LA MESA DESIGN REVIEW BOARD AGENDA

Date: Thursday, July 17, 2025, 11:30 a.m.

Subsequent to the discretionary approvals of the project, the property owner elected to revise the architectural design of the building. Substantial conformance review by DRB is requested to determine whether:

The originally approved project plans are provided as **Attachment C**, and the originally approved colors and materials board is included as **Attachment D**. The proposed exterior changes to the building design are reflected in the updated project plans (**Attachment E**), and the updated colors and materials board (**Attachment F**), and are described below:

WEST ELEVATION PLAN

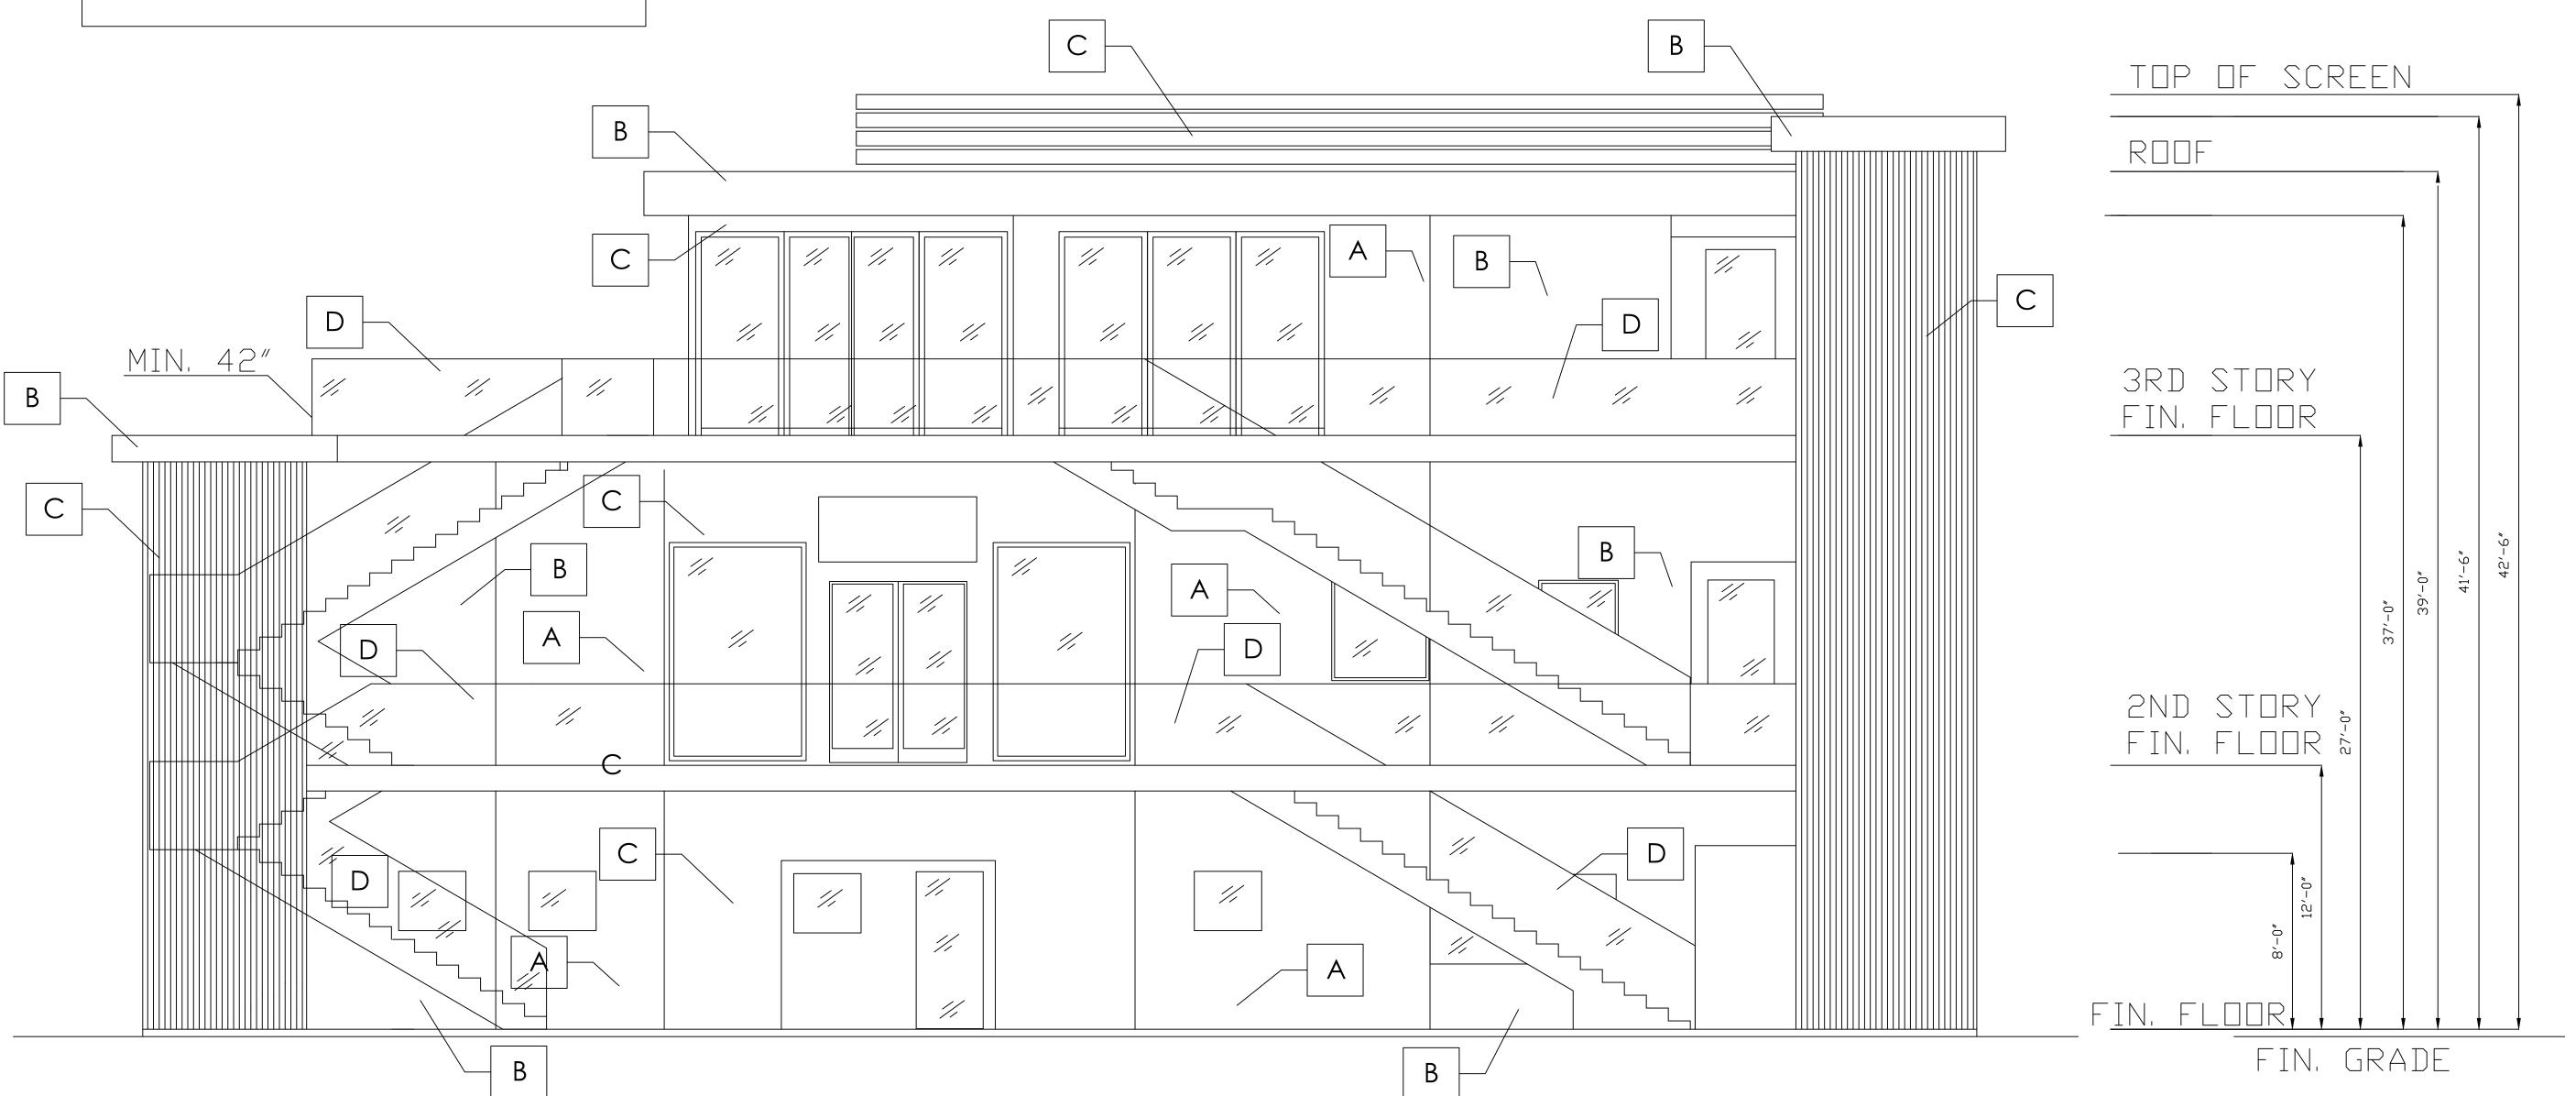
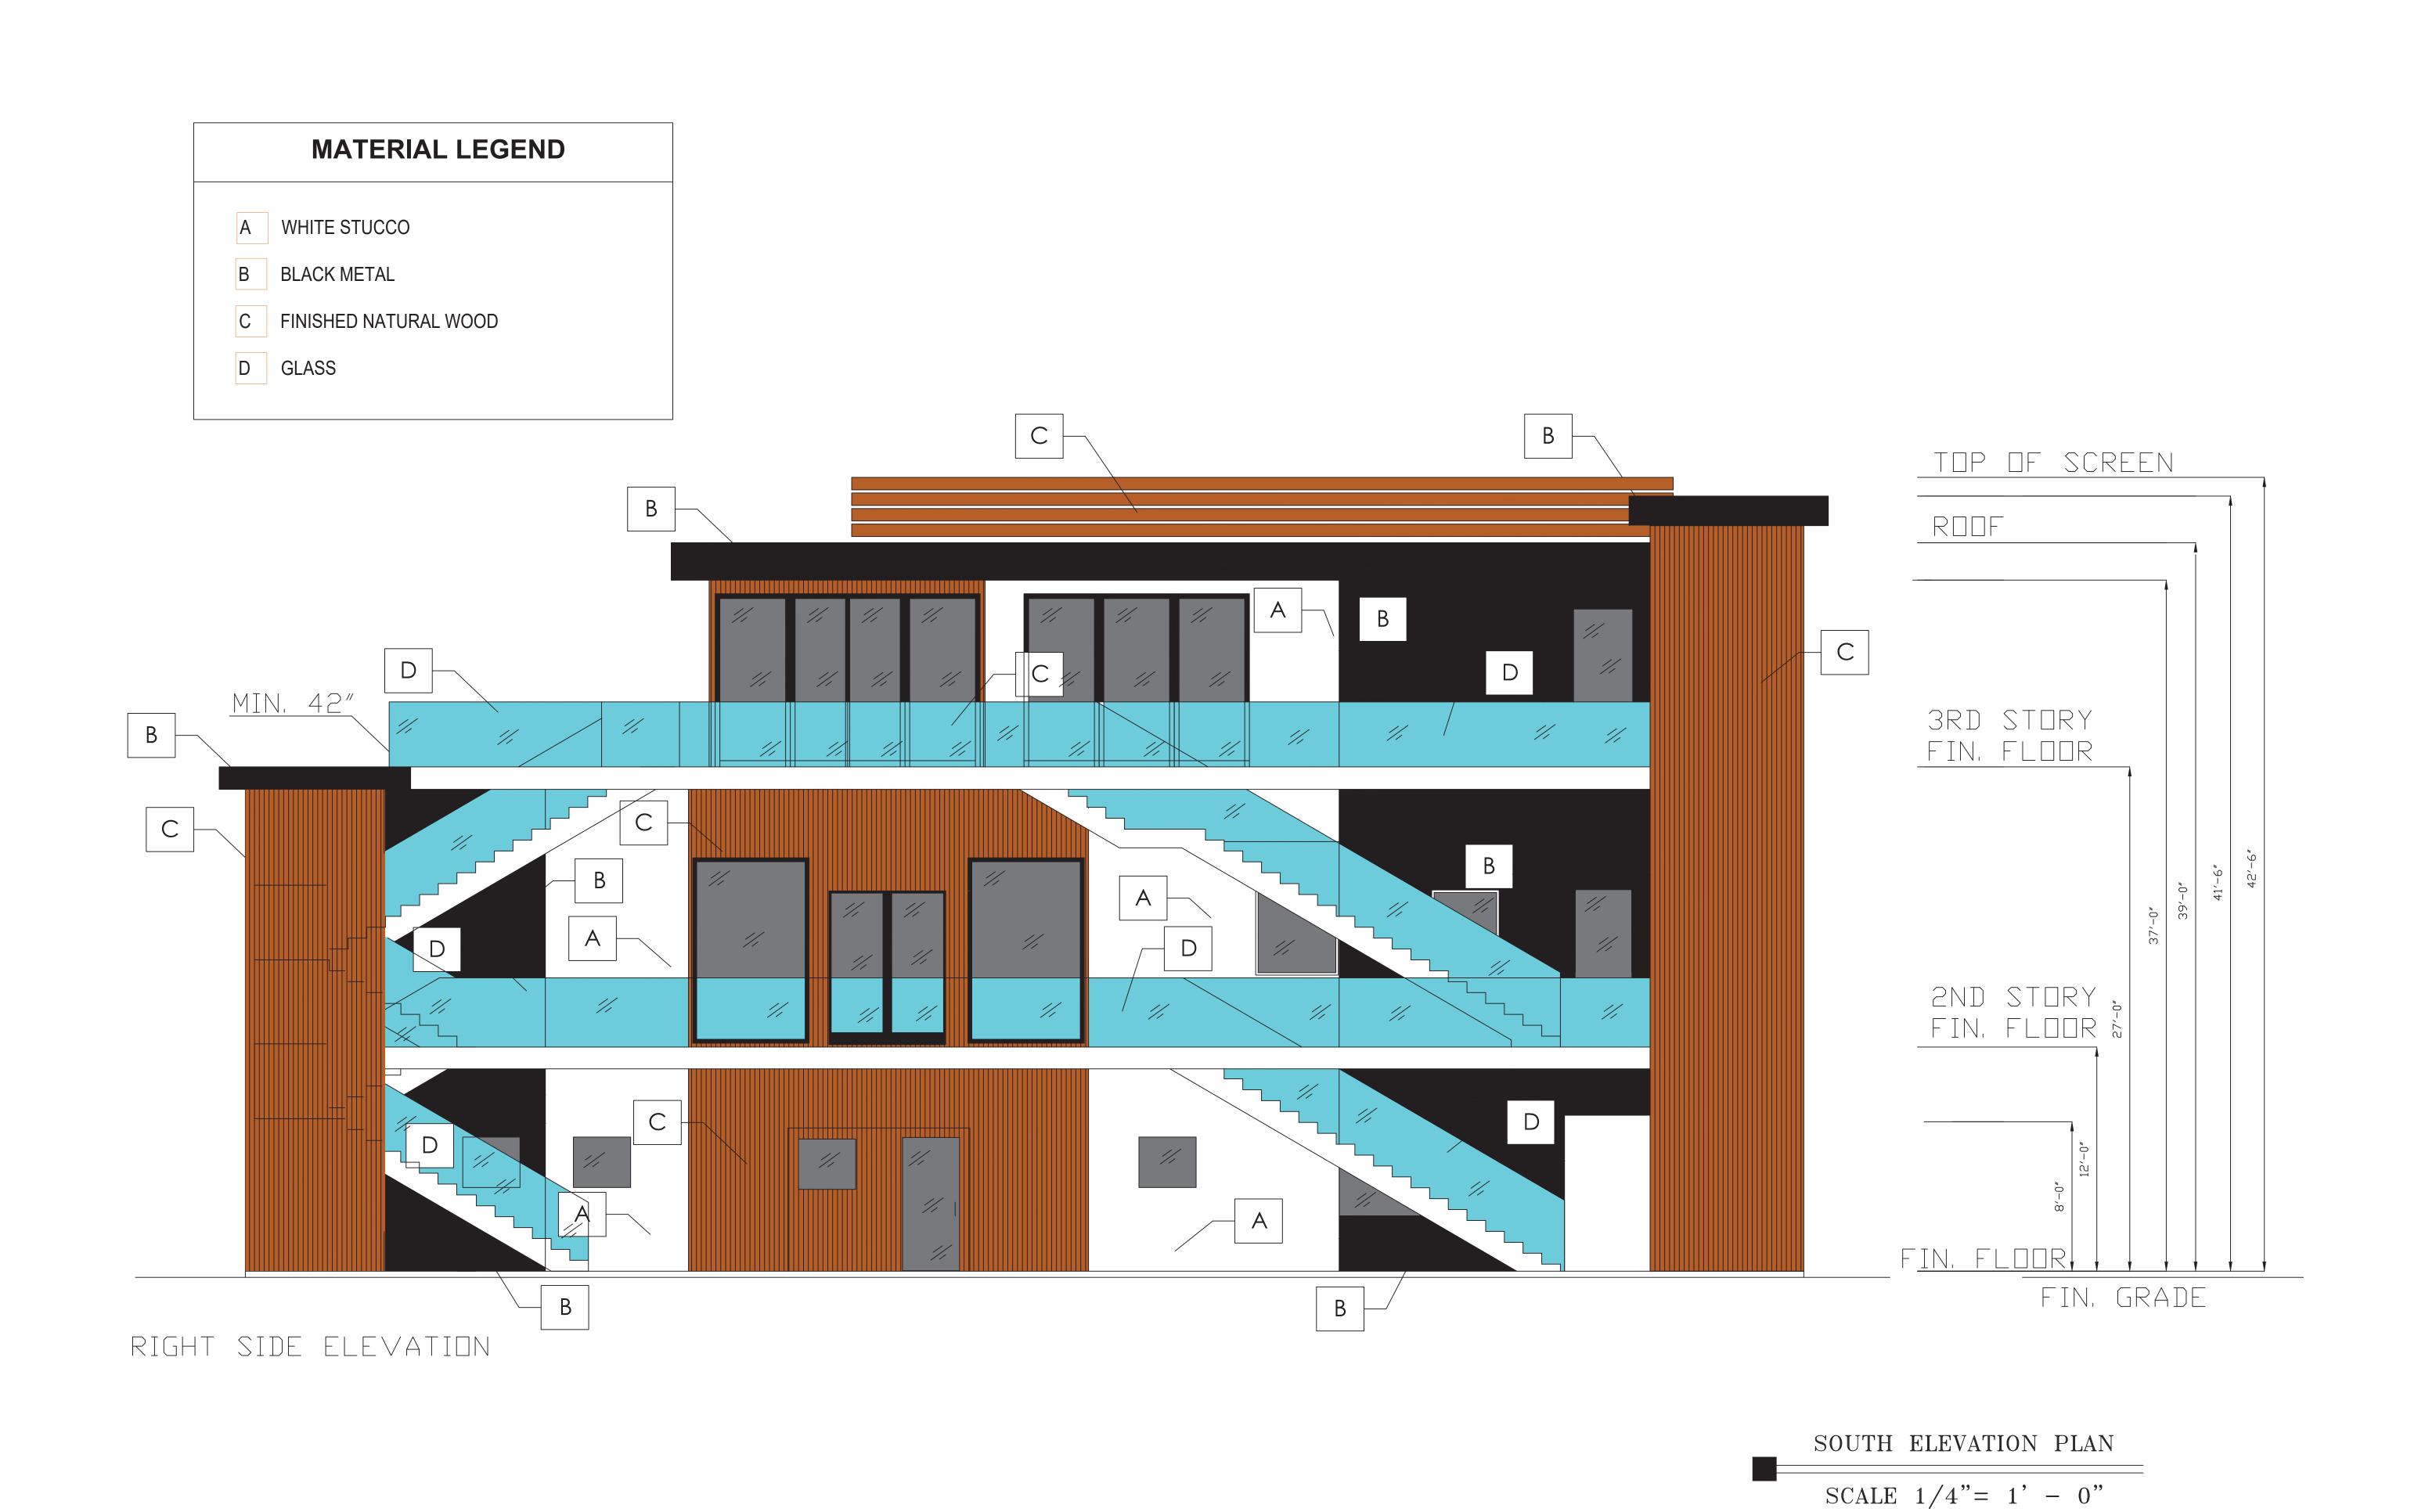
- 1. That the Design Review Board (DRB) provide input on how the applicant may, cost effectively, further improve the west elevation to meet Urban Design Program guidelines.
- 2. That the DRB approve the project, subject to City Council ratification.

EXTERIOR ELEVATIONS SCALE: $3/16^{""} = 1'-0"$

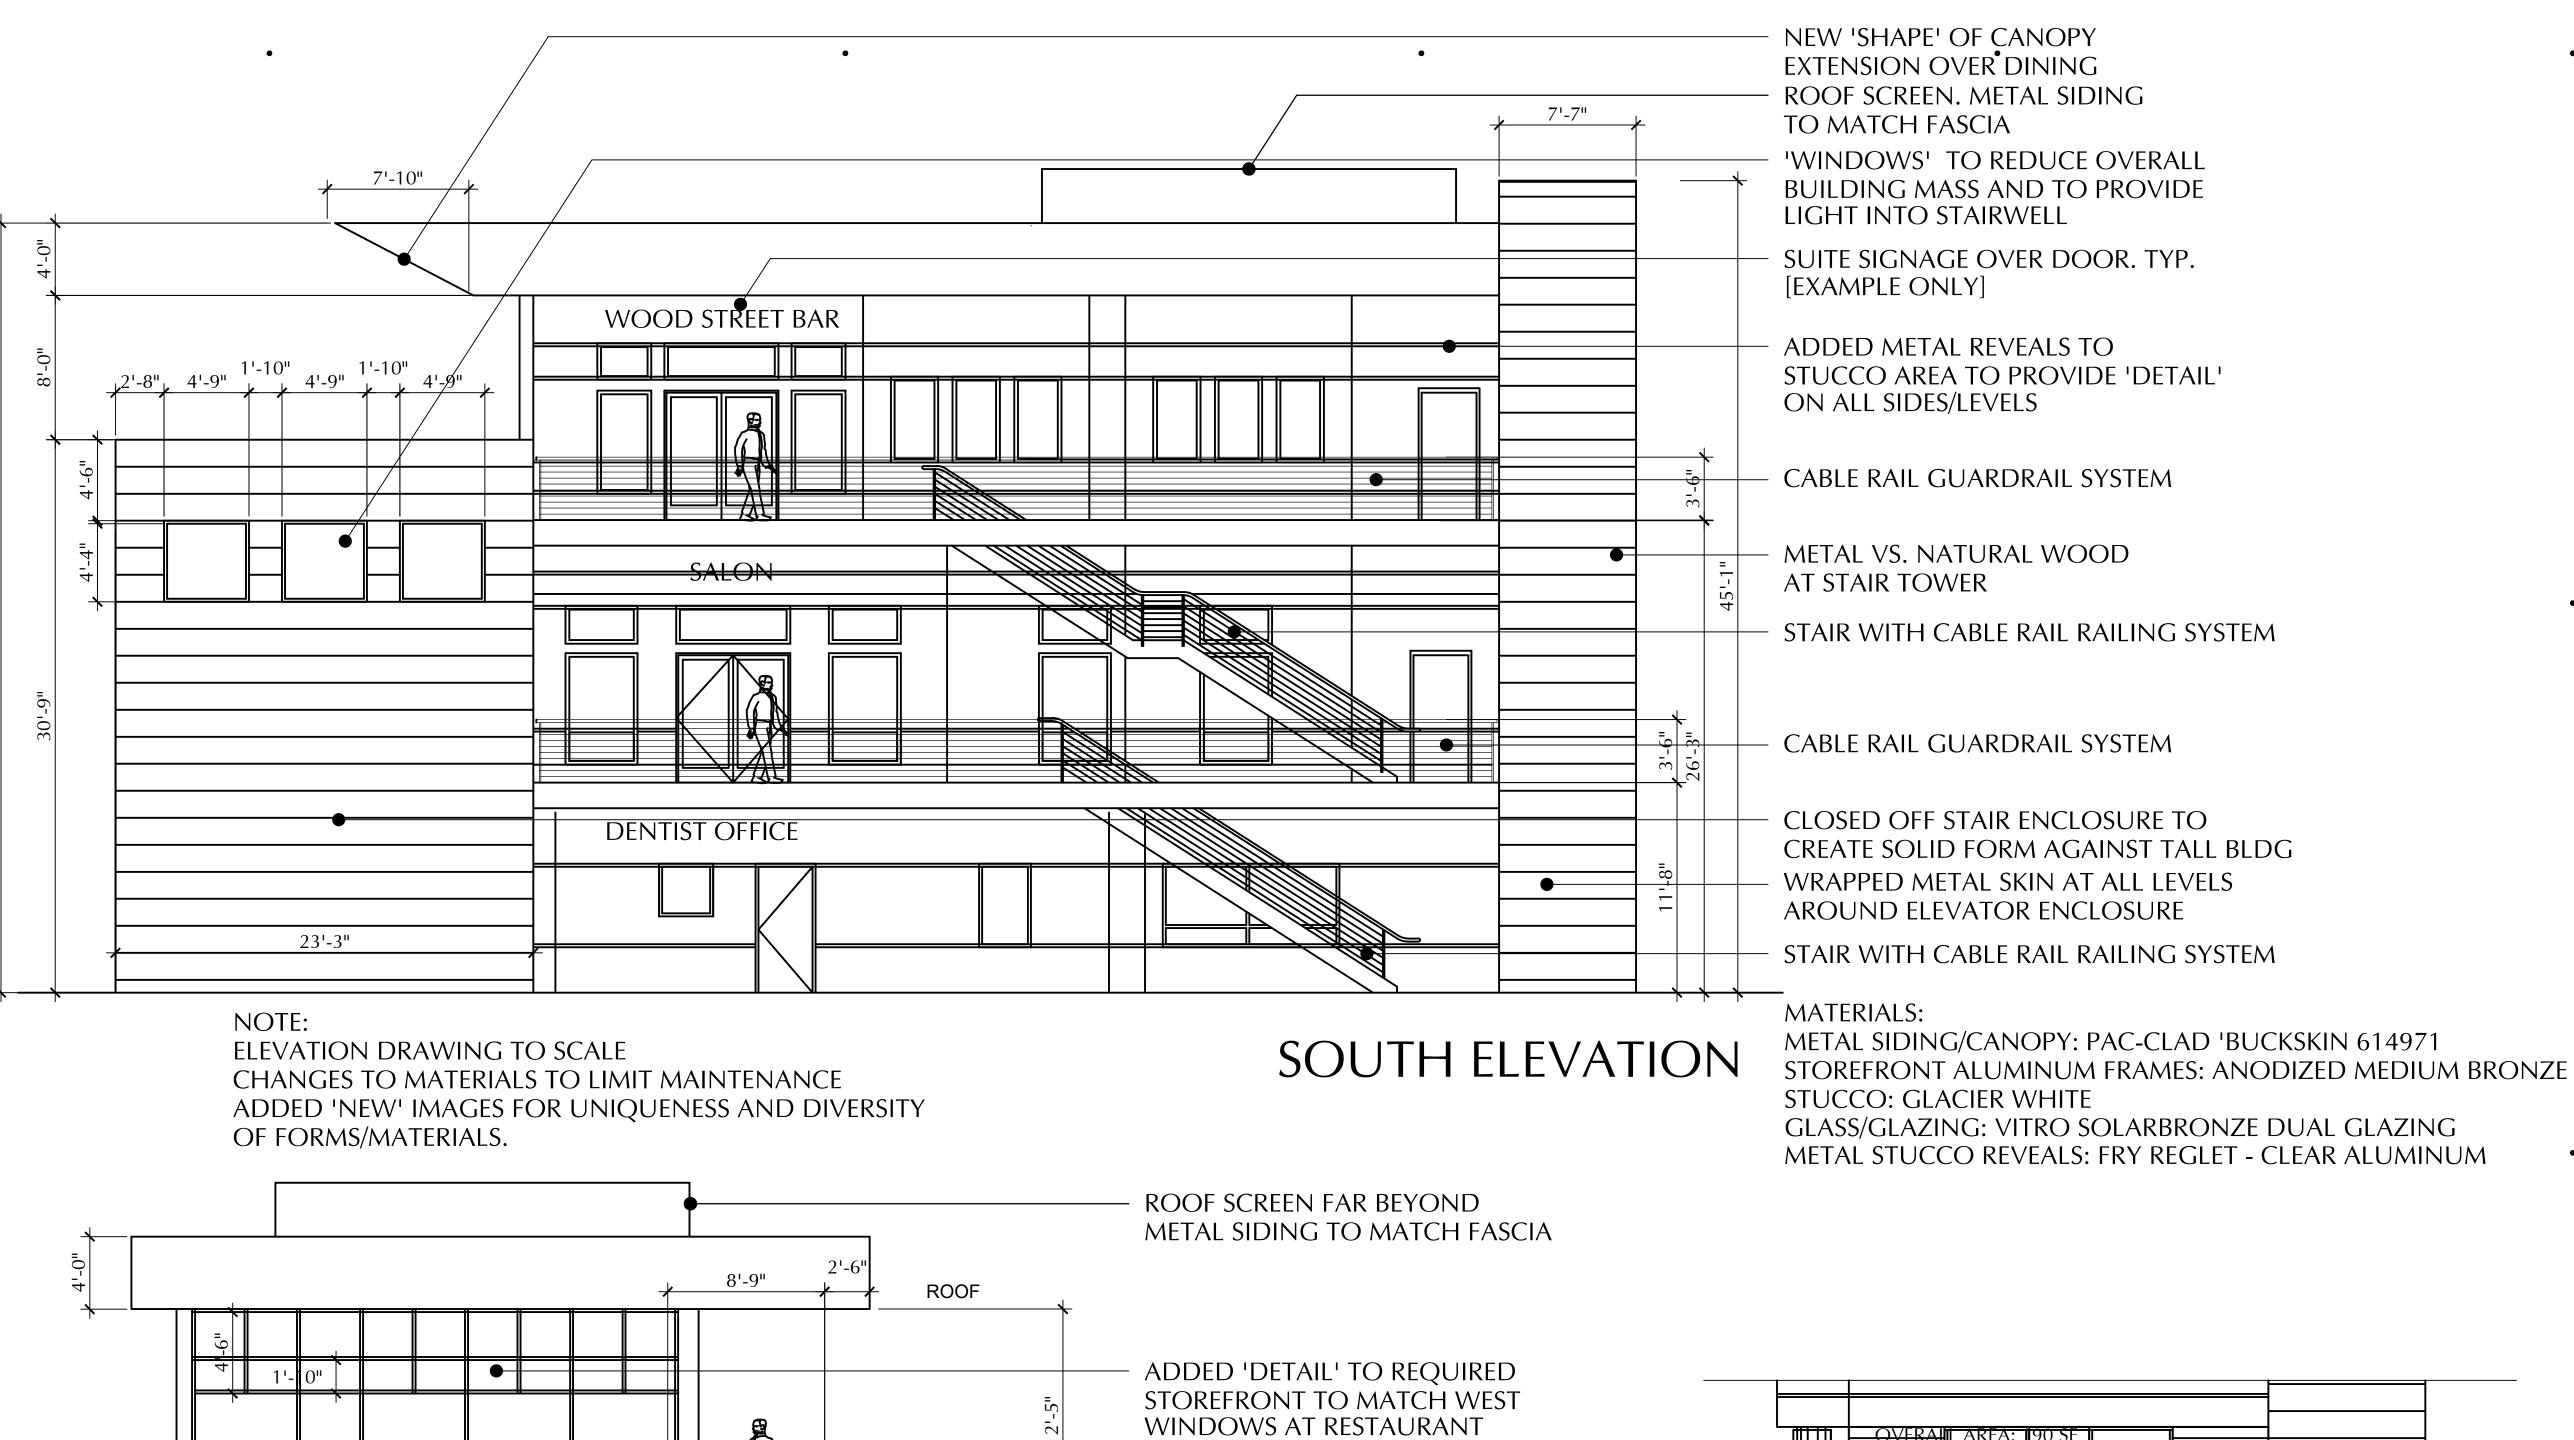
- Shape and size of cantilevered canopy/roof structure revised to angular feature
- Stucco reveals added to building walls on all elevations
- Location, shape and size of windows on all elevations revised, including the addition of a large, circular window on the west elevation

- Removal of occupant signage from west elevation
- Removal of beveled edge on the northwest corner of the building
- Reduced glass railing for rooftop dining (in compliance with the California Building Code)
- Addition of metal wrap columns on North Elevation
- Closed off stair enclosure on both sides (north and south elevations) to create solid form
- Added windows to staircase enclosure on south elevation
- Revised glass railings on south elevation to cable rail guardrail system
